**Tillbridge Solar Project
EN010142**

**Applicant's Response to Examining Authority's
Second Written Questions**
Document Reference: EN010142/APP/9.35

**February 2025
Revision Number: 00**

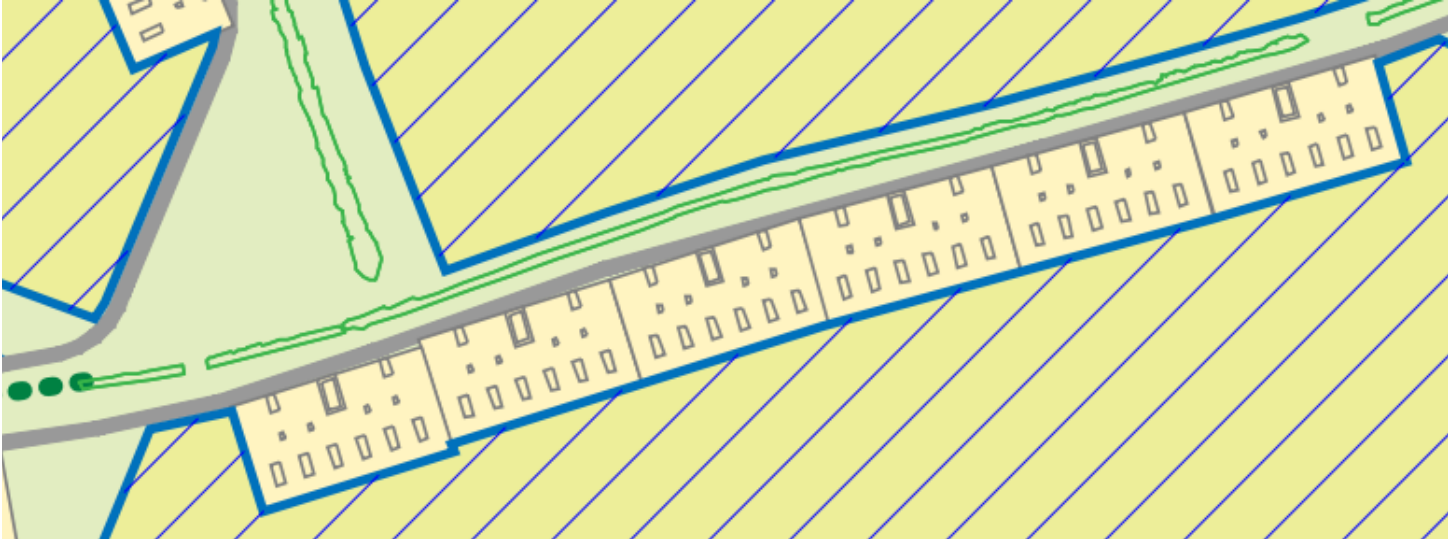
Q2.1.14	Applicant	<p>Amendments to BESS works descriptions and parameters</p> <p>The ExA has reviewed the amended works description and parameters contained within the Outline Design Principles Statement [REP4-021] and Schedule of Changes to the draft DCO [REP4-033]. However, the ExA has the following queries:</p> <p>a) There were previously up to 140 ‘BESS Stations’ specified within the Outline Design Principles Statement. However, there now appear to be up to 50 ‘BESS-Solar Station Compounds’. Furthermore, the maximum footprint of the ‘BESS solar station and BESS compound’ was previously 48mx30m. The maximum footprint of a ‘BESS-solar station compound’ is now 240x30m. Has the assessment in the ES taken this into account? Is the applicant asserting that the most recent indicative layout plan [AS-055] shows a reasonable worst-case scenario based on these revised parameters?</p> <p>The applicant does not appear to have amended the Outline Design Principles statement to ensure that the BESS-Solar station compounds could not be located next to one another (i.e. all compounds in one area of the site). It is noted that the applicant has tightened up the descriptions in the DCO and Outline Design Principles Statement to ensure a DC coupled approach. This is welcomed. Is the applicant asserting that this approach makes it unfeasible to locate the BESS-solar station compounds in a single location and that therefore there is no need for a specific parameter to address this issue?</p>	<p>The Applicant appreciates that as the first DC-coupled Scheme, the terminology and definitions associated with co-locating BESS enclosures with Solar Stations required clarification. These points were set out in detail within Appendix A: BESS Definitions Update to the Written Summary of Applicant’s Oral Submissions at ISH3 [REP4-049], and the Applicant refers the Examining Authority to that Appendix for a full explanation. However, in respect of the two queries raised:</p> <p>ES Assessment of number and footprint of BESS Compounds</p> <p>Appendix A: BESS Definitions Update to the Written Summary of Applicant’s Oral Submissions at ISH3 [REP4-049] explicitly confirms at 1.2.1 section 1.2.3 that the Outline Design Principles Statement amendments “<i>adjust the parameters for the number and size of these features so that these clearly reflect that these are co-located components. This does not change the design approach which has already been applied within the ES, but rather ensures this is clearly captured and set as restrictions within the Outline Design Principles Statement [EN010142/APP/7.4(Rev03)].</i>” Appendix A then provides a further detailed breakdown in section 1.3 of how the parameters as amended align with the various technical chapters of the ES.</p> <p>In short, while the parameters reflected in the Outline Design Principles Statement [REP4-020] have changed, the design used as the basis for the worst-case scenario assessed in the ES has not been amended or changed. The revisions made relate to refining definitions of the components to assist the ExA and IPs in understanding the DC-coupled design approach and to ensure clarity within the Outline Design Principles Statement [REP4-020] in relation to the authorised development as set out in Schedule 1. At the time of submission, what was termed a “BESS station” (to which the footprint of 48mx30m was applied) was a combined Solar Station / BESS Enclosure configuration of the type in the image shown below.</p>

ExQ2	Questions to:	Question:	Applicant's Response:
			<p>This included one “set” of the BESS and Solar Station components, but did not reflect that these can be co-located together in a larger area with multiple sets of components. The new definition of BESS-Solar Station Compound is instead intended to reflect the approach, as has been reflected since application in Figure 3-1: Indicative Principal Site Layout Plan of the ES [AS-055], that each BESS-Solar Station Compound may include multiple BESS enclosures and that each Compound would comprise a differing number of BESS enclosures and Solar Stations. For example, see the configuration from Field 77 in Figure 3-1 below, which shows grouped components:</p> 
			<p>The 140 BESS Stations referred to each individual compound as shown in the first image across the Principal Site even where grouped/multiple BESS-Solar Station Compounds were proposed as shown in the second image within Figure 3-1: Indicative Principal Site Layout plan of the ES [AS-055].</p> <p>The 140 BESS Stations with a dimension of 48mx30m related to the first image above. The 212x30m BESS-Solar Station Compound relates to the second image (Please note there is an error in the ExA Q2.1.14 a) referring to the ‘BESS-solar station compound’ as 240x30m). This depicts the reasonable worst-case and maximum parameter for the BESS-Solar Station Compound which was assessed in the ES, and is intended to directly address the ExA's concerns that all BESS could be co-located in one area. The new dimensions ensure this maximum 212x30m area applies.</p> <p>Control to restrict location of all BESS in one area</p> <p>In respect of the question as to the controls in place to restrict BESS from being located in one area, further to the discussion above the Applicant also notes the specific response to this question within Written Summary of Applicant's Oral Submissions at ISH3 [REP4-049] at page 17, specifically that:</p> <p><i>In respect of the particular queries raised regarding restrictions on where the BESS could locate and if there was restriction preventing the BESS being located in a small number of locations, the</i></p>

ExQ2	Questions to:	Question:	Applicant's Response:
			<p><i>Applicant notes the following design details and controls outlined within the Outline Design Principles:</i></p> <ul style="list-style-type: none"><i>• The Outline Design Principles require the BESS and Solar Stations to be co-located together in BESS-Solar Station Compounds. Solar Stations, by design, must be located close to the solar PV fields, as they include the relevant equipment for the operation of those panels, and location at greater distances from fields would require excessive and expensive cabling across the site to account for any distance.</i><i>• Maximum parameters have been set for the BESS-Solar Station Compounds so as to ensure they cannot be built larger than the worst case presumptions of the size of the Compounds as assessed in the ES. This precludes BESS being co-located together in larger areas than these maximum extents (212 x 30m).</i><i>• Maximum parameters in respect of effects also control the extent of BESS and their location within the site. For example, compliance with Requirement 17, in respect of operational noise, will require any BESS installations to be designed such that they comply with the noise levels assessed in the ES (which assumes a spread of smaller areas of BESS throughout the site).</i> <p>Finally, as set out in Appendix A: BESS Definitions Update to the Written Summary of Applicant's Oral Submissions at ISH3 [REP4-049], when the Applicant seeks to discharge Requirement 5 for approval of the detailed design of the Scheme's layout, including location of the BESS Solar Station Compounds, the Applicant will need to demonstrate (1) that the BESS-Solar Station Compounds have been designed in accordance with the relevant Outline Design Principles and (2) pursuant to the procedure set out in Schedule 17 to the draft DCO, that the effects resulting from the detailed design submitted for approval are no worse than those set out in the ES. Part (2) of this process is an additional check to ensure BESS-Solar Station Compounds could not be grouped together in such a way that introduced materially new or materially different environmental effects (e.g. in relation to noise or visual) compared to those in the ES. Other controls and design requirements would also influence the siting of the BESS- Solar Station Compounds, such as Requirement 17 which relates to operational noise, as explained below, and the locational requirement for Solar Stations to co-locate next to the solar PV panel areas.</p>

Figure 1 Indicative Construction Periods for the Tillbridge Solar Project and Nearby Solar NSIPs

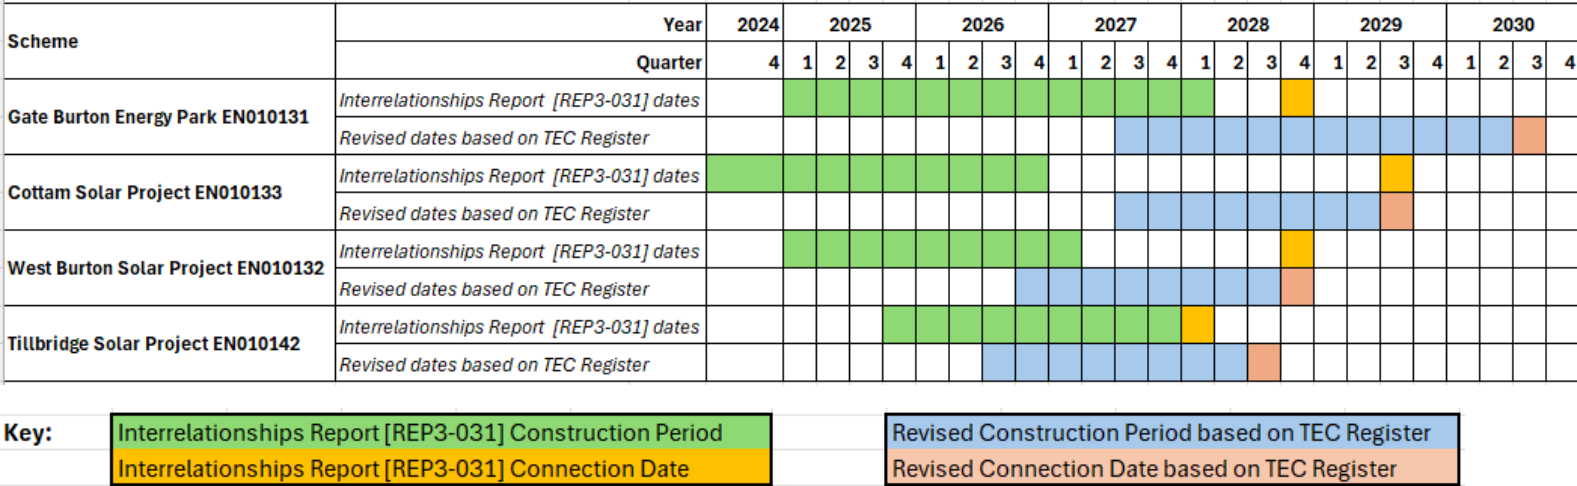
ExQ2	Questions to:	Question:	Applicant’s Response:
Q2.5.1	WLDC	<p>Cumulative Construction Period</p> <ul style="list-style-type: none">• In responding to Q1.1.6 [REP3-067] WLDC provides justification to support its assertion that cumulative construction could last for ten years. However, the response also states:• ‘<i>To confirm, WLDC does not object to the cumulative assessment in the Tillbridge ES</i>’. <p>How can this be the case when the assessment of cumulative effects contained within the ES [REP4-015] is based on two scenarios, with the longest comprising a cumulative construction period of 5 years?</p>	No response required from the Applicant.
Q2.5.2	Applicant	<p>Cumulative Construction Period</p> <p>7000 Acres' response to Q1.1.6 [REP3-092] states in part: <i>'What the applicants have failed to advise the ExA’s is that according to the NESO Tec Register dated 26 November 2024, the earliest grid connection date is 01/08/2028 with the last project having a connection date of 31/10/2029. Applying similar durations and timing relationships to the Design, Construction and Commissioning activities, but relating the completion dates to align with the grid connection dates, results in an entirely different sequence for the projects. We have assumed that the applicants would not want a completed project to sit unused for any length of time, so have delayed the start of design until later for some projects.'</i></p> <p>Could the applicant please provide a response to this specific point and provide evidence of the earliest grid connection dates available? Please also confirm whether these dates have any bearing on the assessment undertaken within the ES?</p>	<p>The Applicant confirms that the National Energy System Operator (NESO) Transmission Energy Capacity (TEC) register (Ref 1-7) includes the latest available connection dates, however the Applicant notes that the Scheme’s and any cumulative schemes’ connection dates are indicative and may change.</p> <p>The Applicant provided a response to this comment at Deadline 4 within the Applicant’s Comments on Interested Parties Submissions to the First Written Questions at Deadline 3 [REP4-048], which stated in part that the cumulative environmental effects are not likely to be materially different, if the start dates of the projects were changed, and the magnitude of any cumulative impacts would be less, if the construction peaks did not overlap.</p>

Figure 2.1.17.1: Winter Day Energy Yield

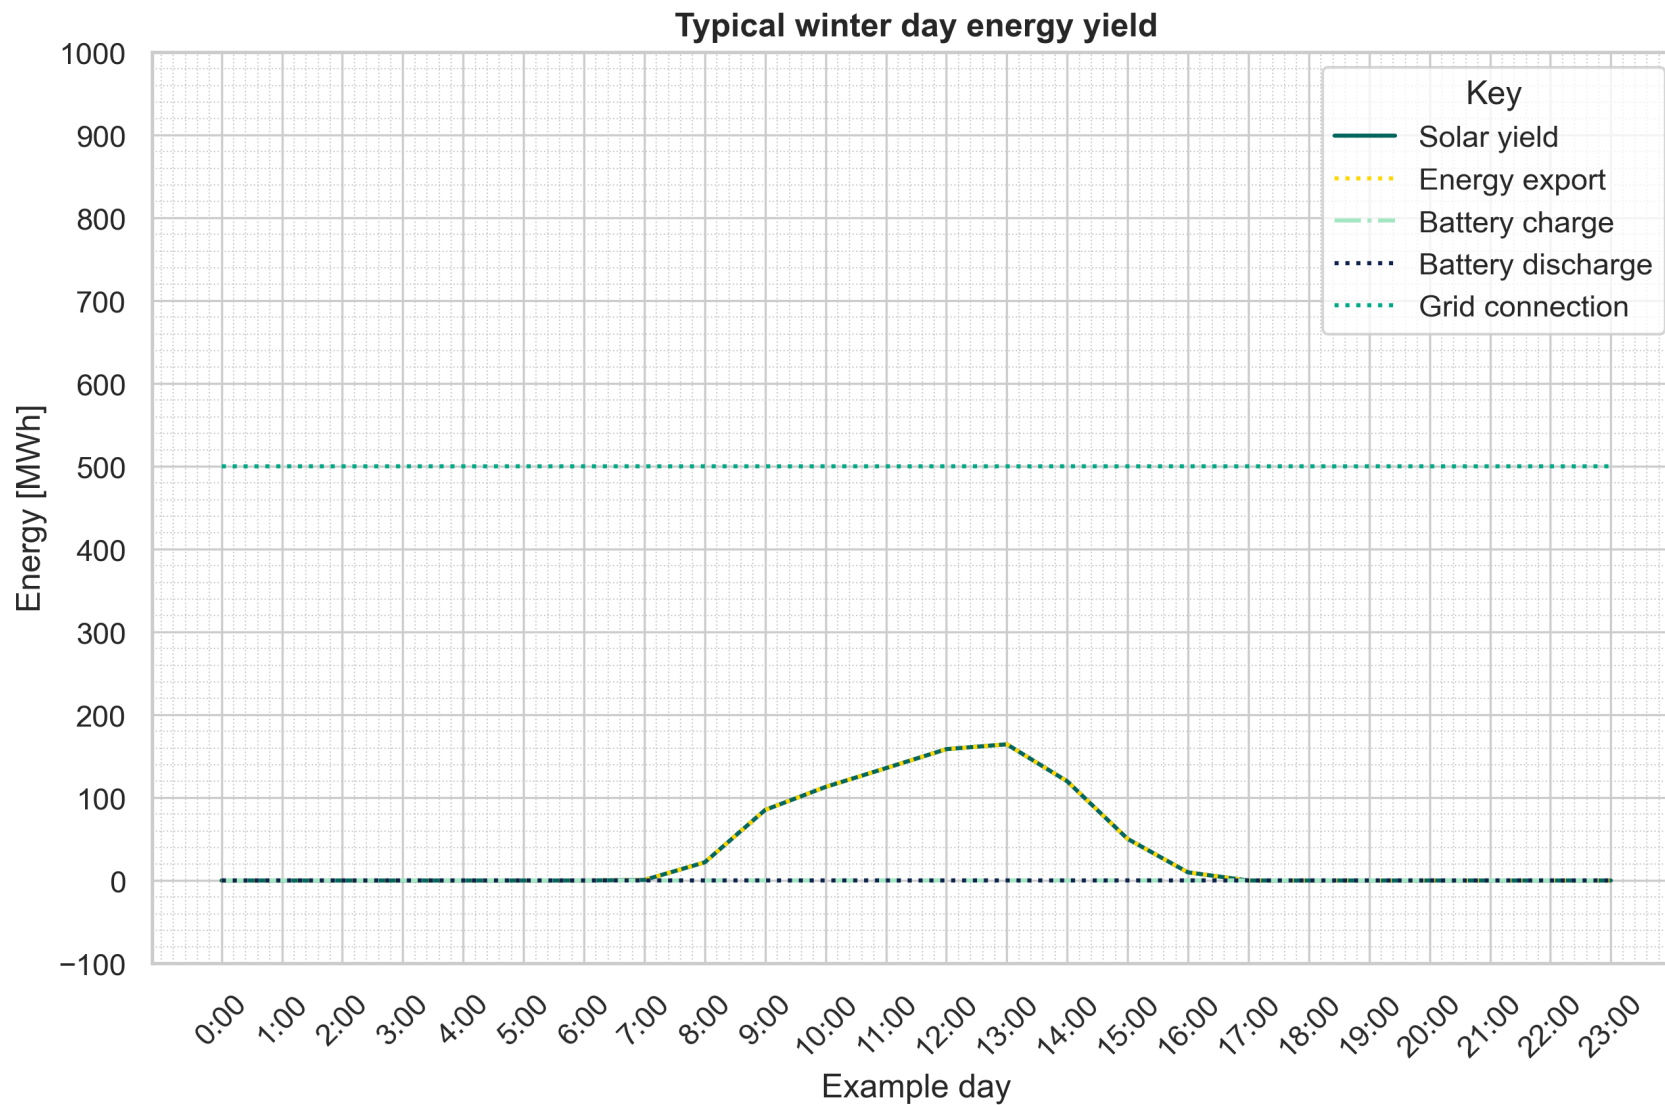
Q2.1.17	Applicant	<p>Efficiency</p> <p>The illustrated example day in [REP01-046] would appear to be a typical summer day when irradiance levels are high. Could the Applicant please provide a further example day of typical low irradiance levels, such as might be experienced during mid-winter, and also what the yields for this day over time might look like in comparison with the example day previously shown.</p>	<p>The Applicant's response to this question has been provided within Appendix D of this document.</p>
Q2.1.18	Applicant	<p>Degradation</p> <p>The Applicant provides estimates of solar panel degradation over time. Can the Applicant also provide an indication of battery degradation over time and the potential likelihood and frequency of battery replacement over the life of the project?</p>	<p>As detailed in REP3-010, paragraph 3.2.4, Table 3-1, the ES assesses that batteries have an indicative design life of 5–15 years, and assumes they will be replaced on average every 10 years over the operational life of the Scheme. Unlike solar panels, battery degradation is influenced by various factors, including technological advancements, operational conditions, and usage patterns. Battery technology is continuously improving, resulting in lower degradation rates and extended lifespans. A key factor affecting battery longevity is the number of charge-discharge cycles, which currently ranges between 5,000 and 15,000 cycles depending on the specific battery type and manufacturer. The ES assesses a reasonable worst-case scenario for degradation of batteries in terms of the frequency of replacement; however, a more precise degradation pattern can be determined at the detailed design stage.</p>

- **Figure 2.1.17.1 - Winter Day Energy Yield:** The first figure presents a typical winter day energy yield at the Scheme's location. The grid connection capacity is set at 500 MW, and it can be observed that the energy yield remains consistently below this threshold due to lower irradiation levels, as referenced in the question.

Annex A – Figure 1

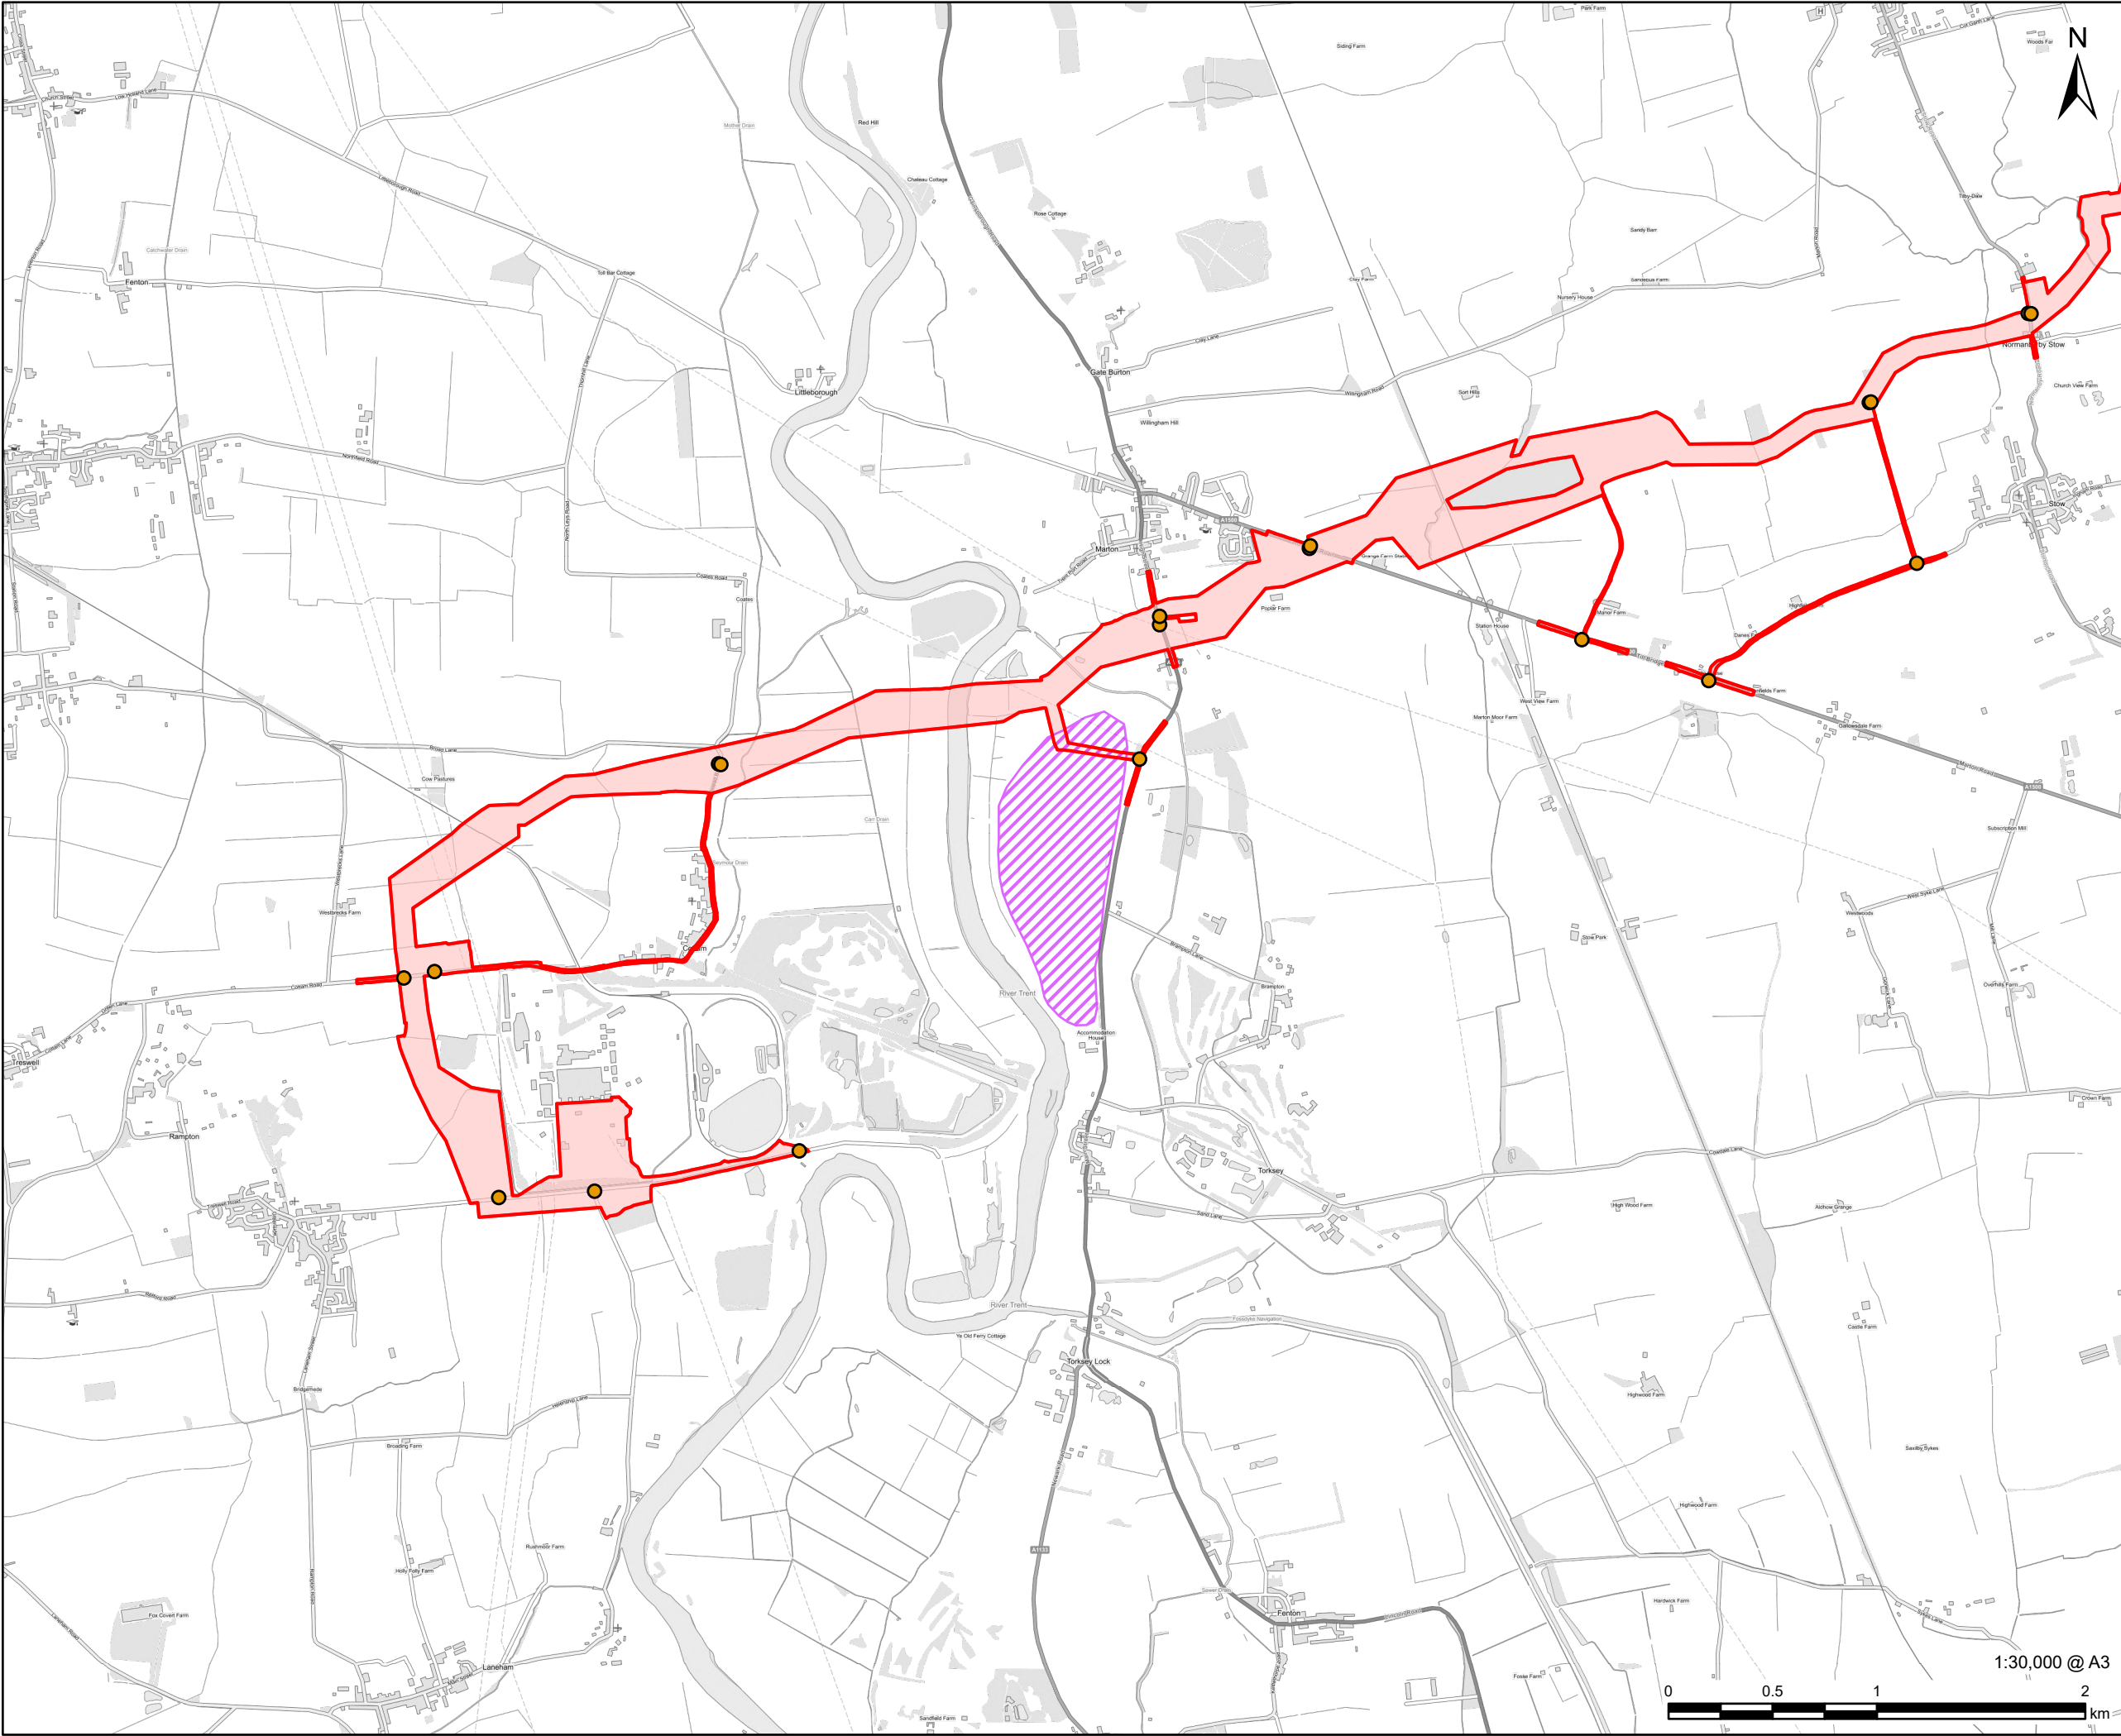
- B) Please could the applicant provide a plan showing the location and extent of this archaeological site in relation to the order limit boundary?*
- C) Could the applicant please confirm the cumulative effect of the proposed development along with Cottam and Gate Burton, bearing in mind the applicant's response to Q1.1.3 [REP3-062] and the assertion that there is a need 'to retain some minor flexibility within the Order limits to ensure that no one project prevents another coming forward should all DCOs be made'?*

- 3.1.1 The Winter Camp of the Viking Great Army at Torksey [MLI125067] is located to the south-west of the village of Marton, on a bluff overlooking the east bank of the River Trent. **Figure 1**, provided within Annex A of this document, shows the location and mapped extent of the asset, as provided by the Lincolnshire Historic Environment Record (HER) on 22 August 2023 when HER data was requested to inform the desk-based assessment prepared to support the Environmental Impact Assessment (EIA) for the Scheme. It is possible that the Winter Camp covered a larger extent, as suggested by a multi-year archaeological research project, the Torksey Viking Project, carried out by the Universities of York and Sheffield (Ref 1 and Ref 2). The results of the project, which mapped findspots of early medieval metalwork and coins, alongside the results of fieldwalking, targeted geophysical survey and test pitting, suggest that the extent of the Winter Camp of the Viking Great Army at Torksey may be larger than that recorded by the Lincolnshire HER, covering an area of approximately 55 hectares (ha).

3.1.12 Please refer to **Figure 1**, which is included in **Annex A** of this document.
